Groundwater Transfer Review Summary Form

Transfer/PA # T- 14466

Application: T-14466

Applicant Name: Eagle Eye Ventures – Eva and Dan Henes

Cross-section A:

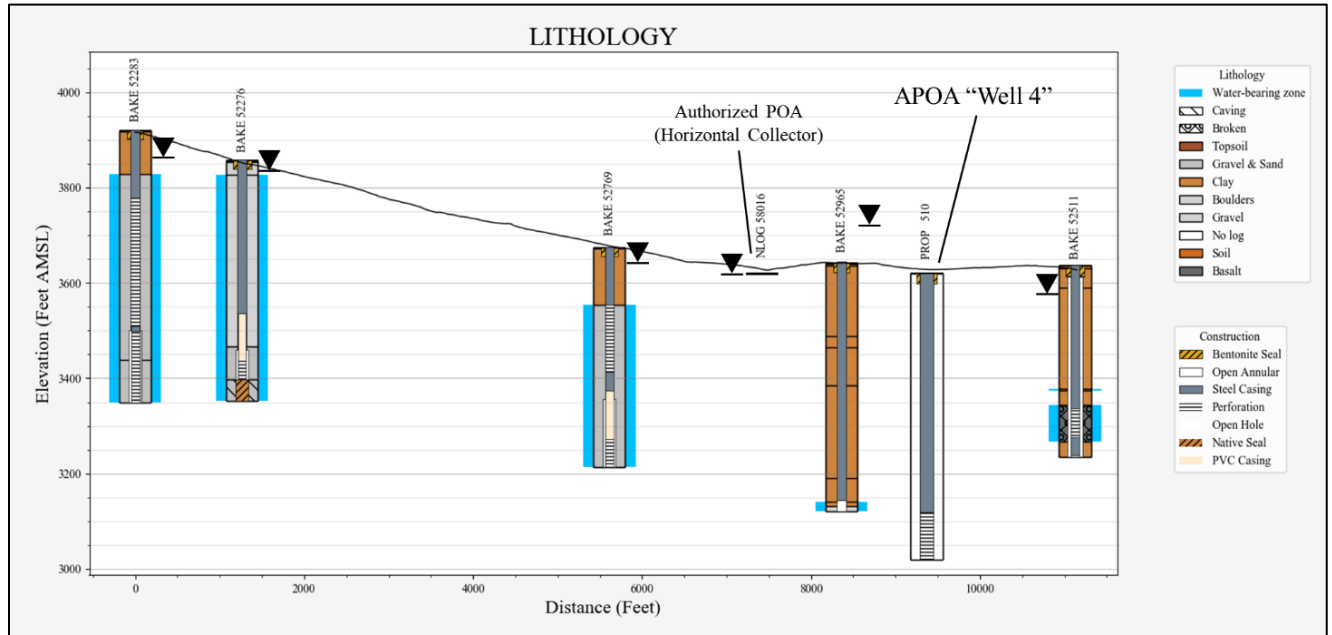
Recently constructed well BAKE 52965 is within 1,500 feet of, and constructed to similar depth as, the proposed APOA wells, with the same water-bearing gravels being the target for production. This target aquifer reports high artesian pressure near 80' above land surface within BAKE 52965, which is significantly different than other nearby wells that are somewhat shallower (see attached cross-section).

The biggest concern with the proposed changes is that currently authorized near-surface collector wells limit groundwater production to what emanates in the near-surface and therefore limits the potential to overdraft the aquifer system, where drilling deep wells to access the same water eliminates this limitation, possibly causing a more substantial drop in hydraulic head elevation and leading to a cessation of discharge from the local artesian system and inevitably to local surface water. The second major risk is that the targeted high-pressure system is not found at the location and depth anticipated, in what are likely to be expensive wells based upon the proposed construction.

Special Condition: To prevent overdrafting of the source aquifer, any APOA wells producing groundwater from the aquifer producing artesian flow in BAKE 52965 shall be limited to pumping only when the groundwater elevation is above the elevation of the lowest currently authorized POA well (3,580' AMSL).
